Village of Cassopolis

CWSRF Interceptor Force Main Replacement

ADDENDUM 1

June 12, 2026

Sheet FM-8.2 – N Mill Street Force Main Plan and Profile Sta 5+00 to 10+00

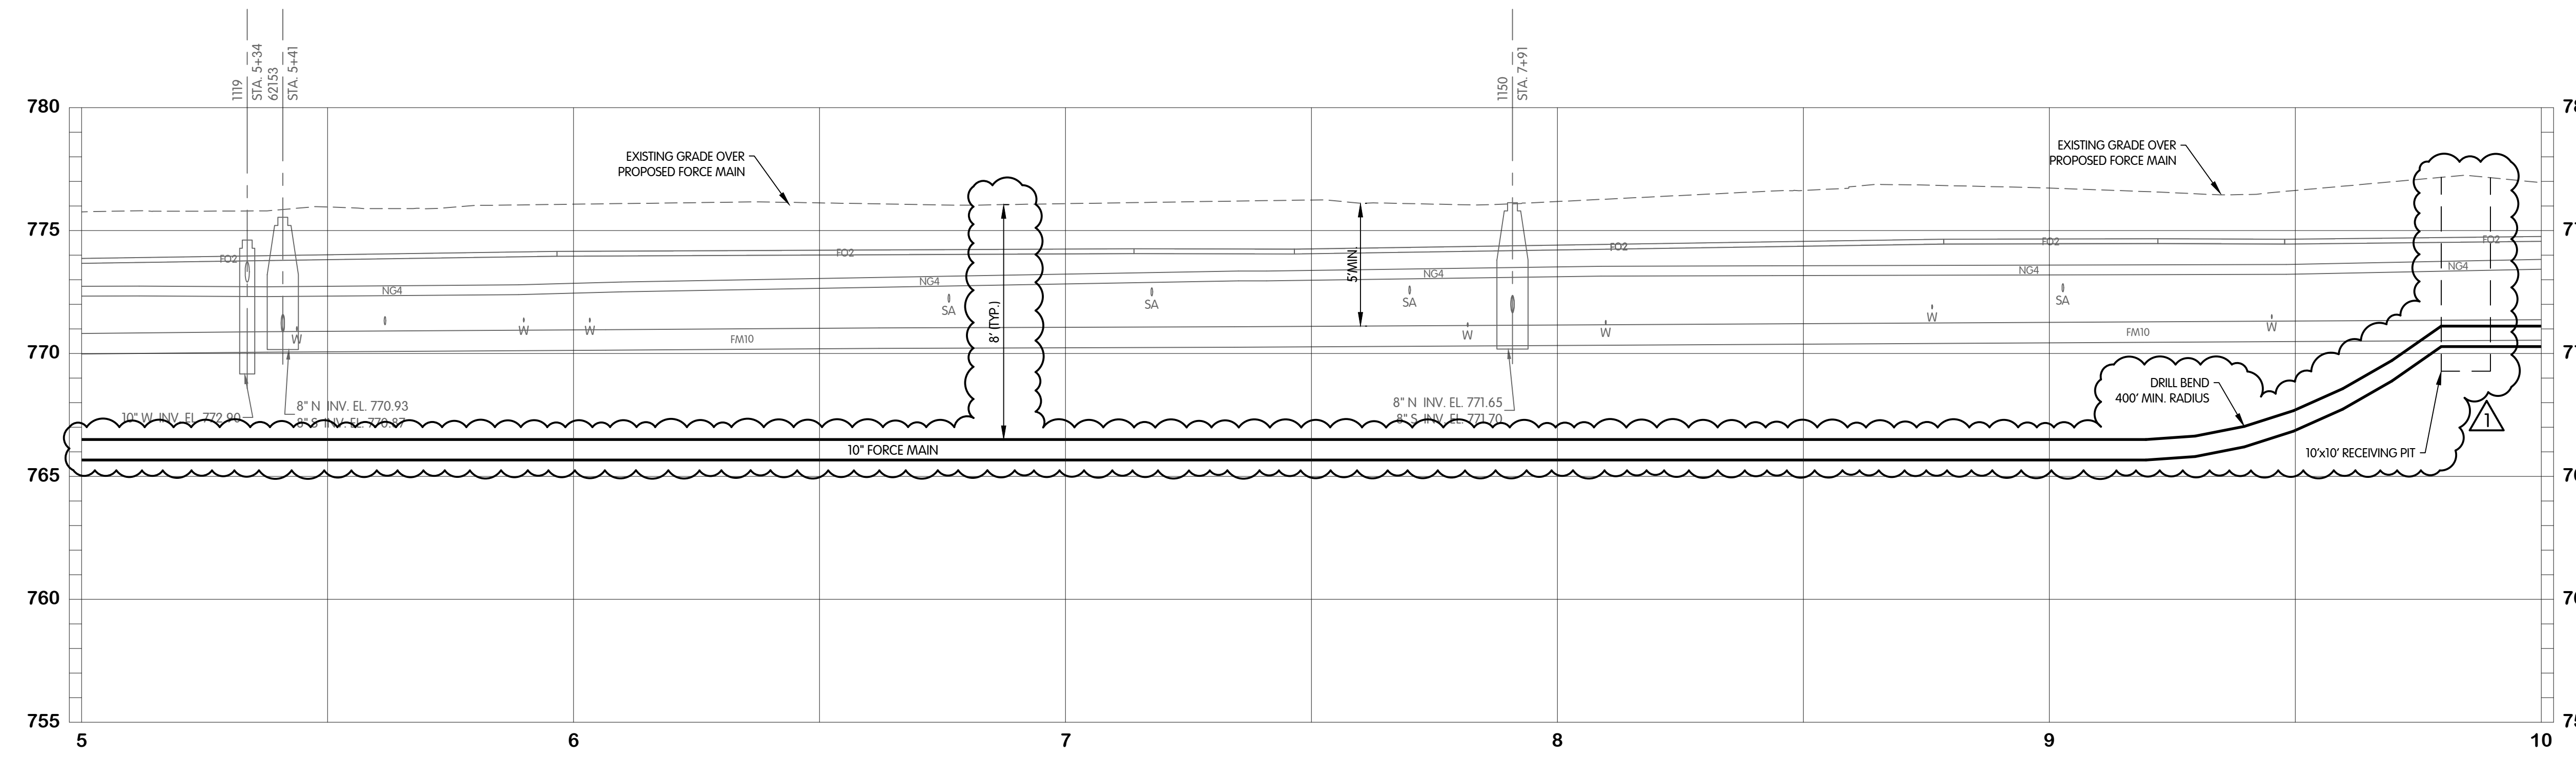
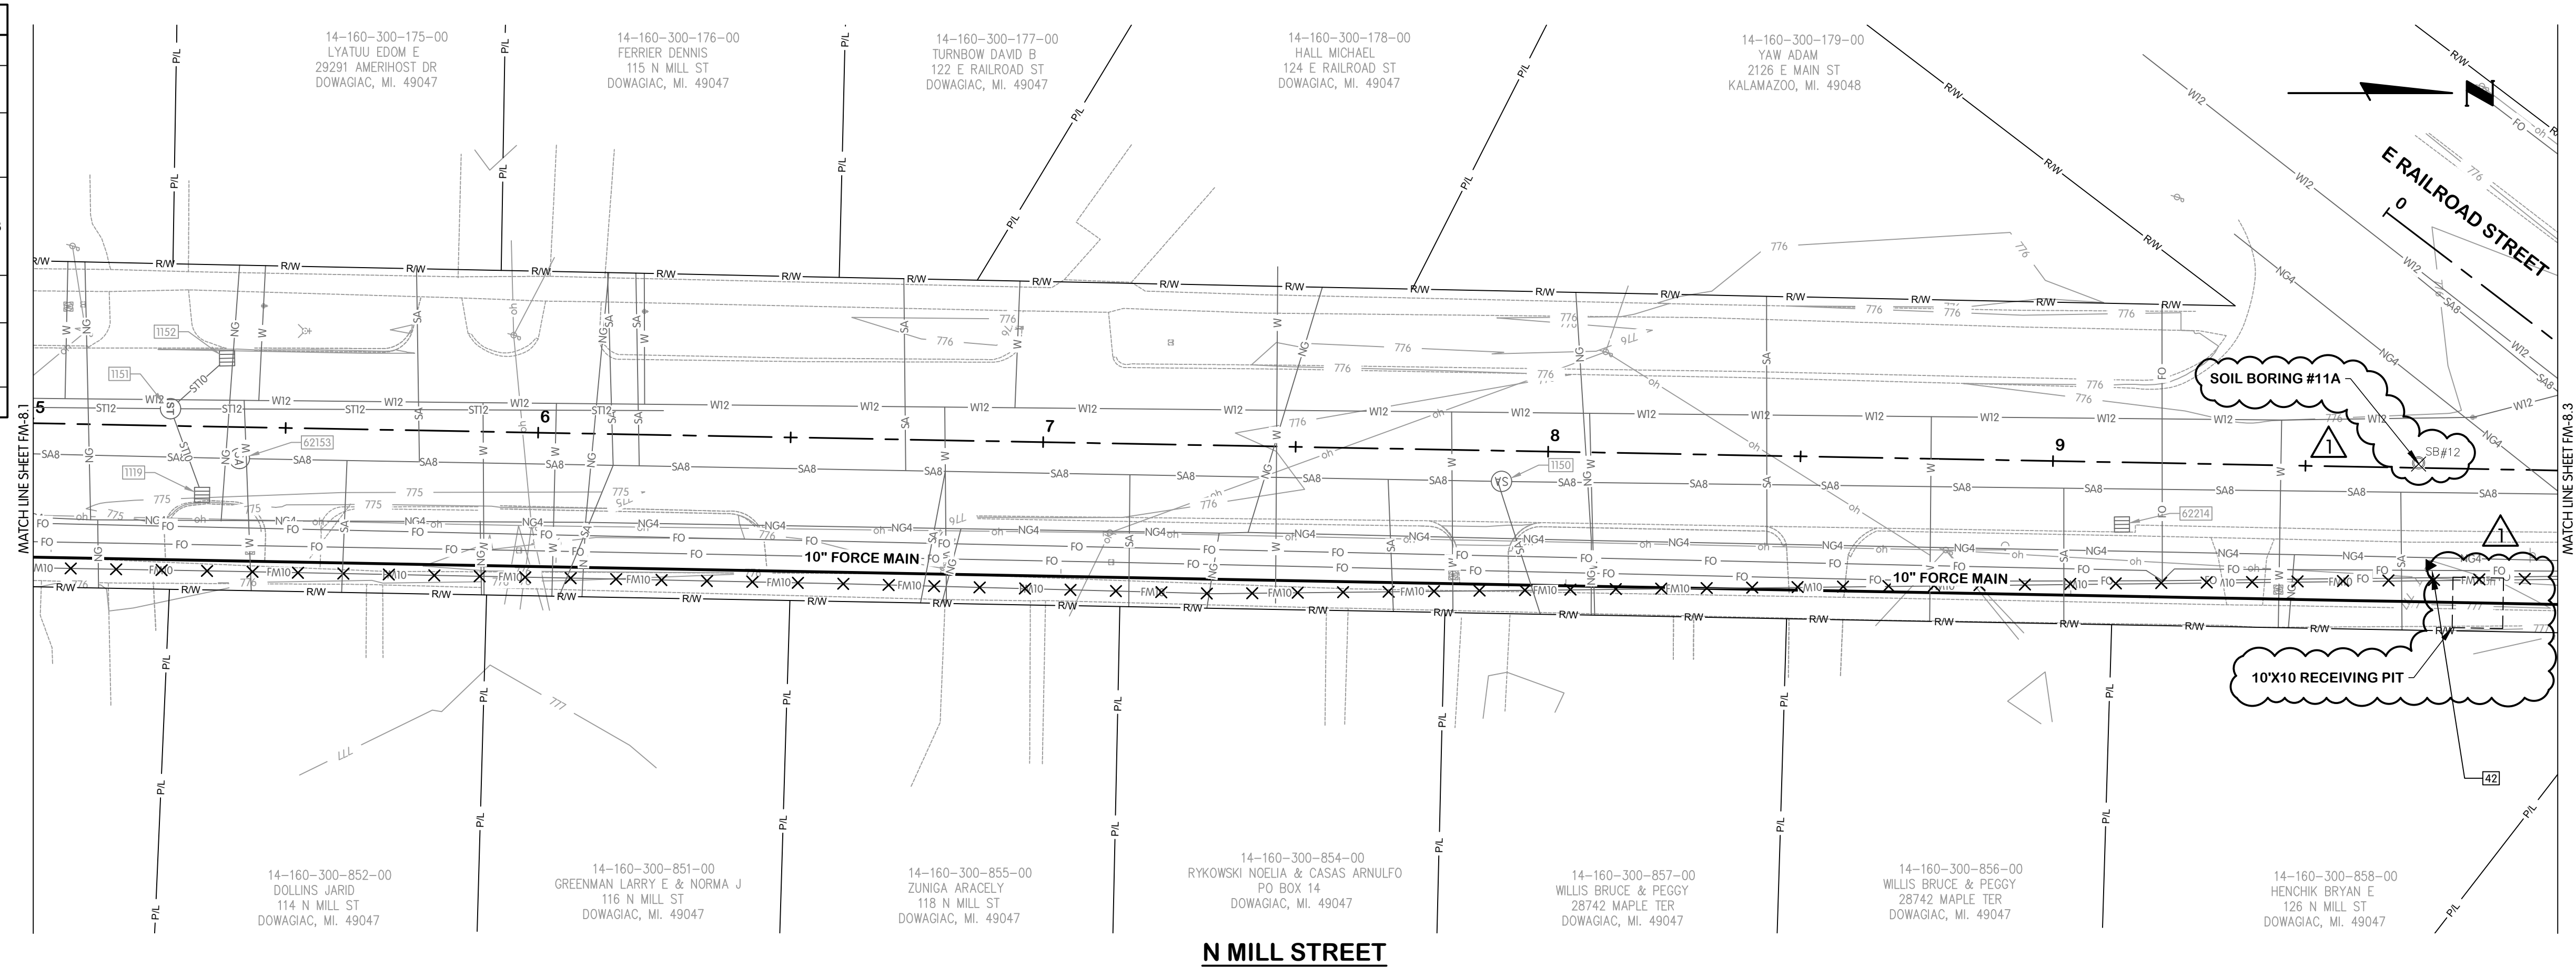
A portion of the alignment was modified and changed from open cut to horizontally-directionally drilled pipe. The north arrow was also added to this sheet. Replace the sheet with the provided Sheet FM-8.2 included with Addendum 1.

Horizontal Directionally Drilled (HDD) pipe shall be installed with a minimum bend radius of 400 feet. This note has been added to all plan sheets depicting HDD installations. Revised plan sheets will not be reissued solely for the inclusion of this note. Bidders and all relevant parties shall acknowledge and incorporate this requirement into their work and construction planning.

Sheet FM-9.1 – E Railroad Street Force Main Plan and Profile Sta 0+00 to 5+00

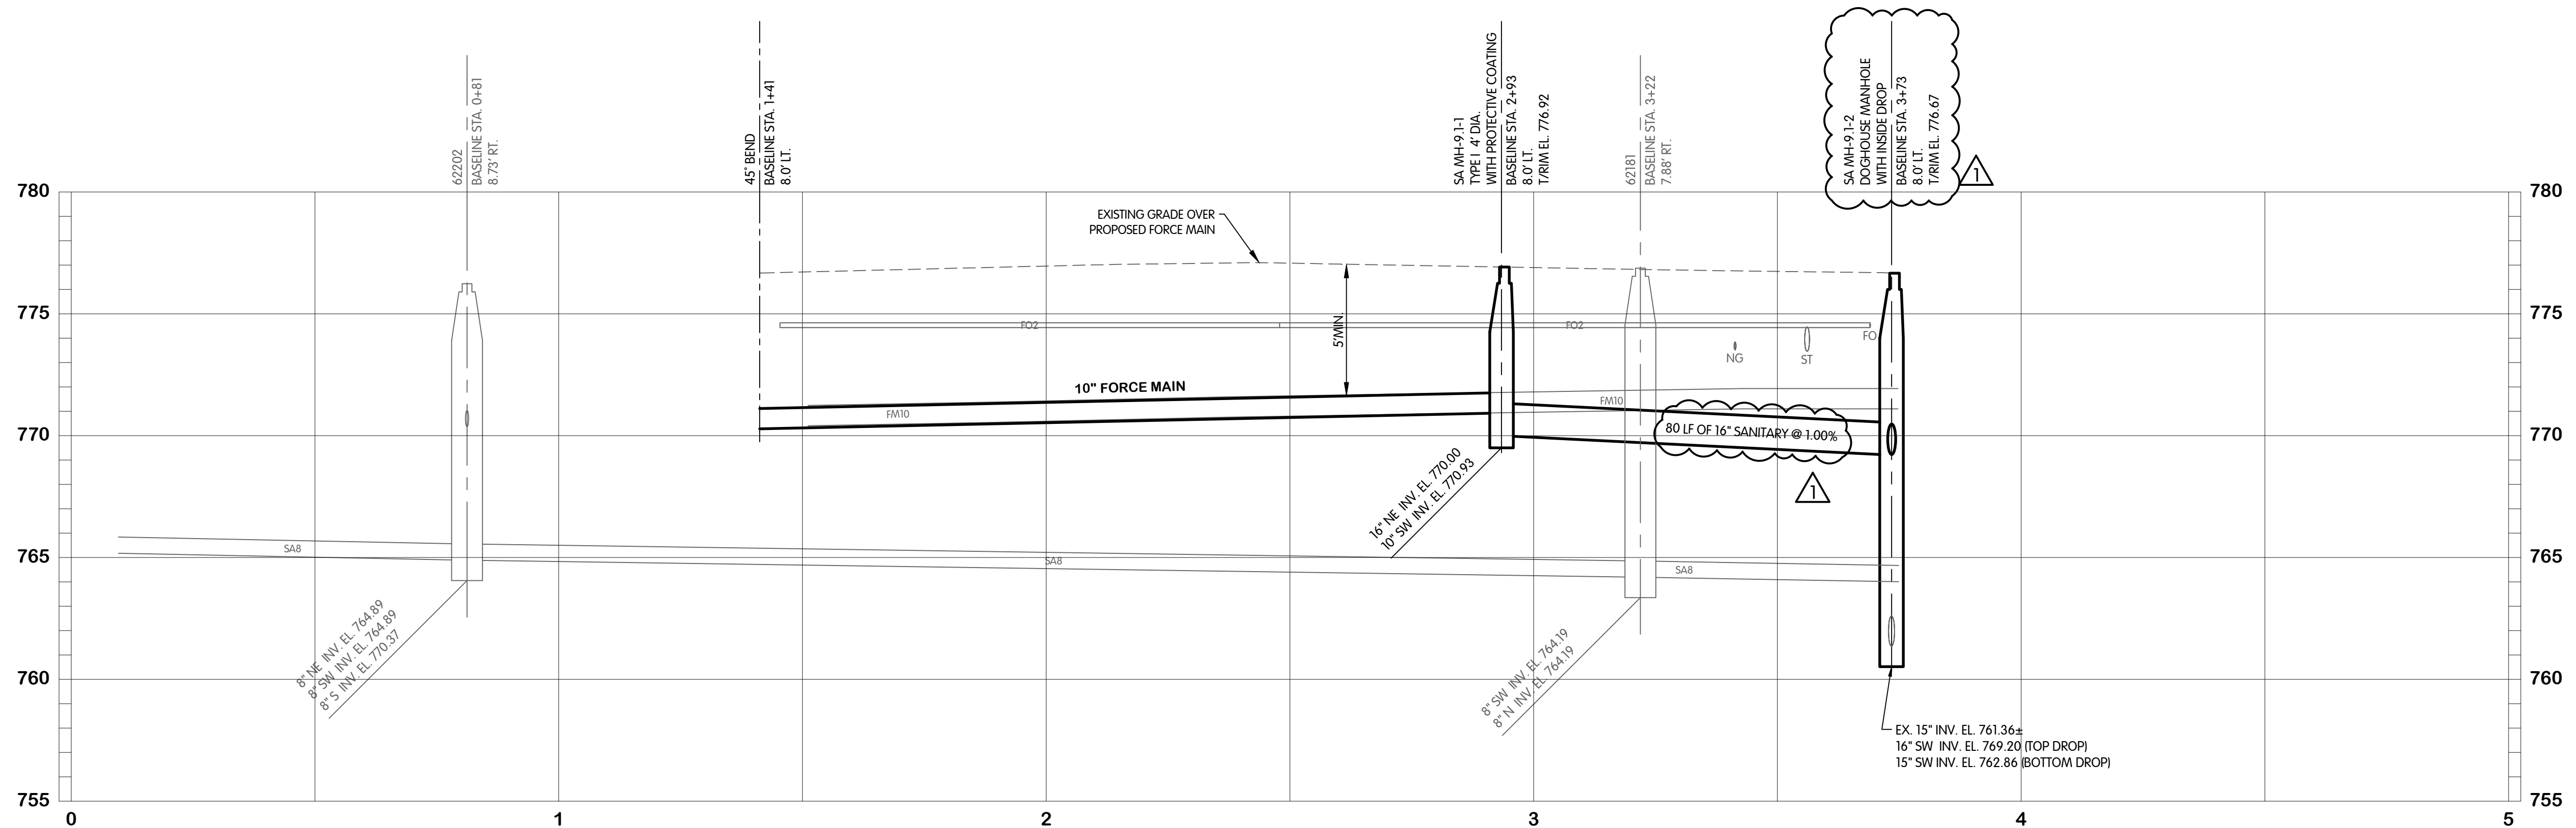
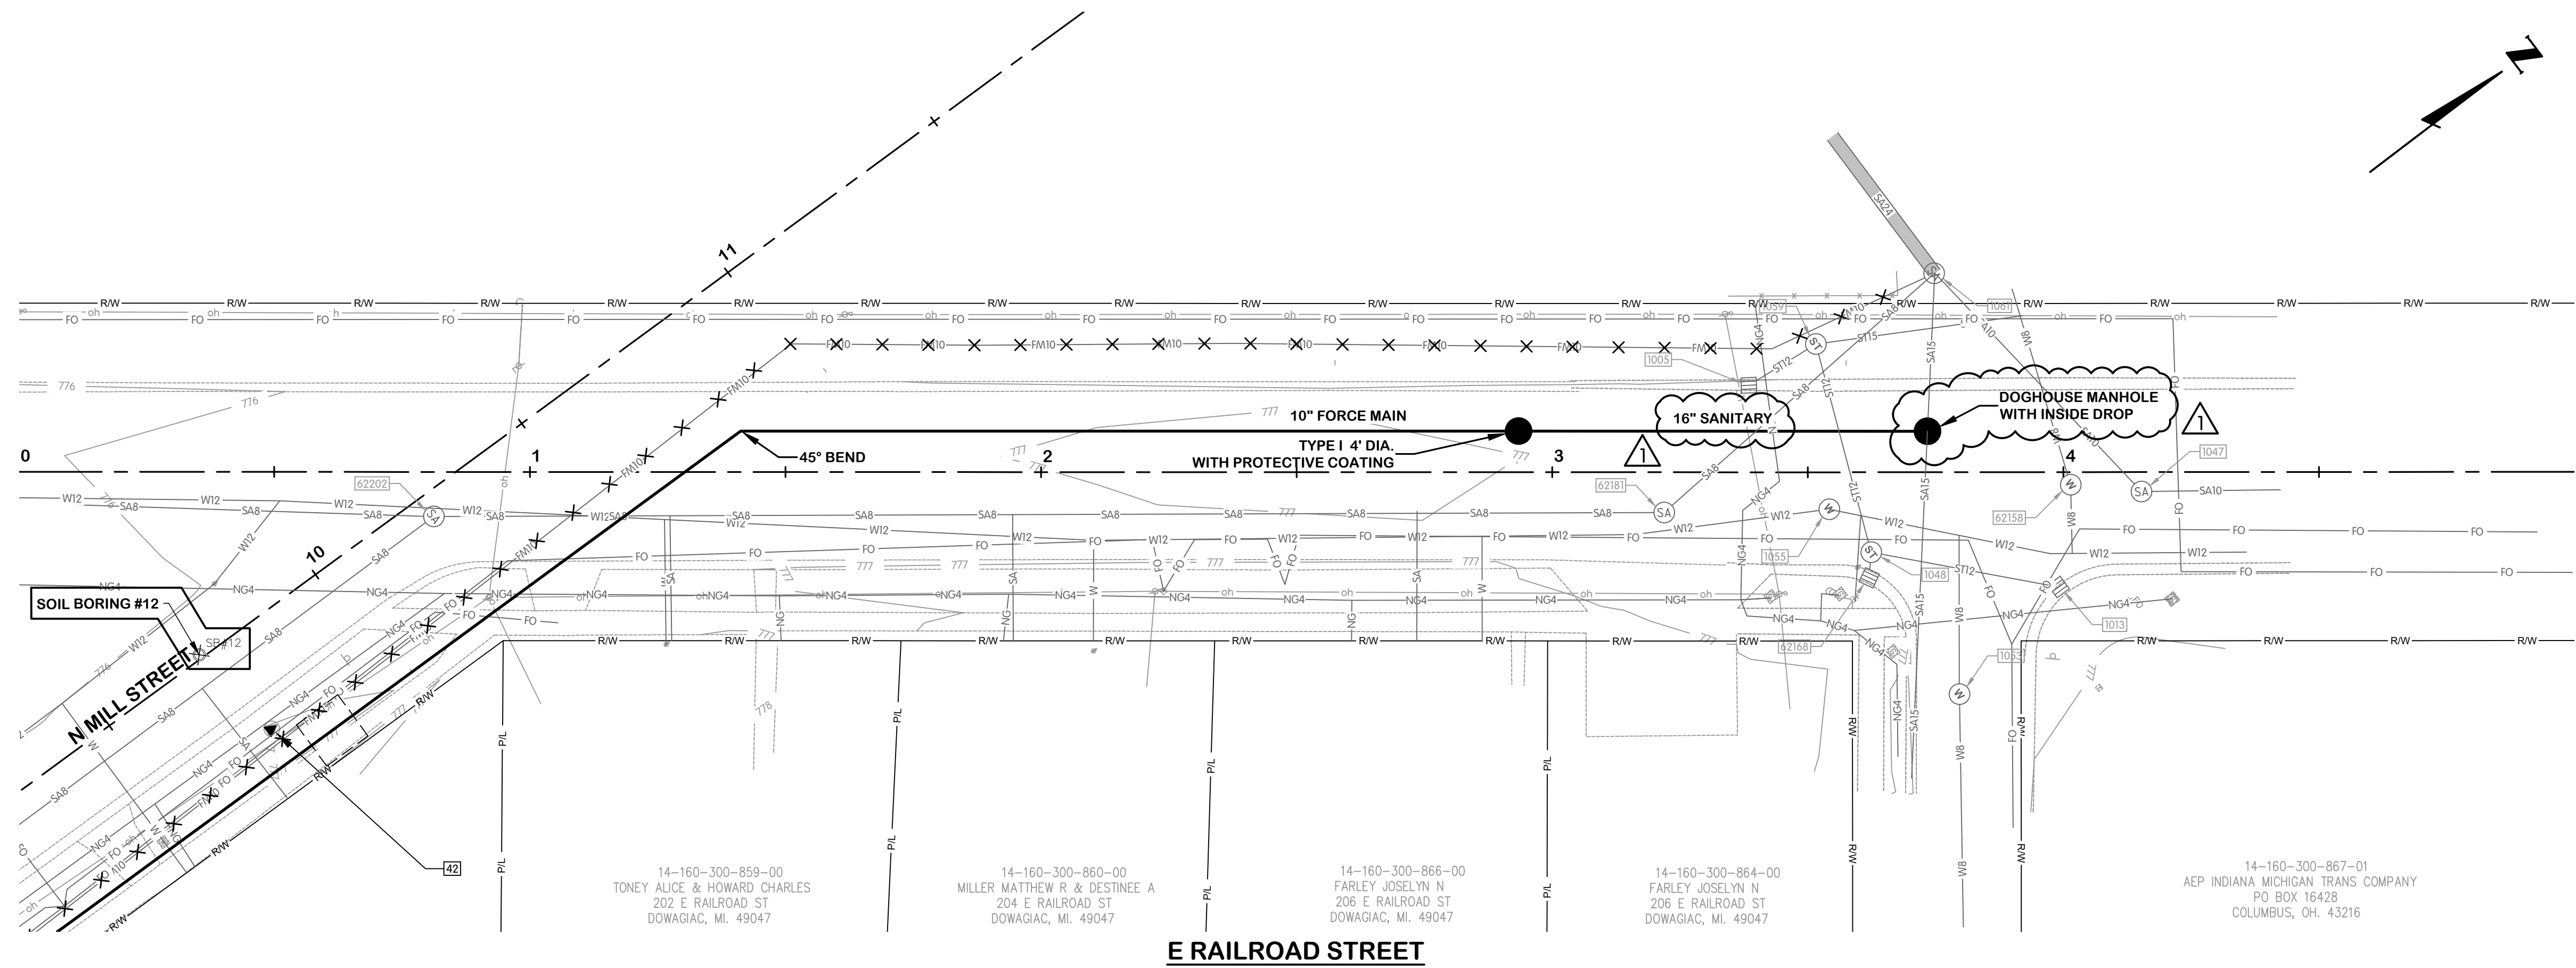
A portion of the alignment was modified and the north arrow was added to this sheet. The 15-inch gravity sewer pipe was replaced with 16-inch diameter pipe. Replace the sheet with the provided Sheet FM-9.1 included with Addendum 1.
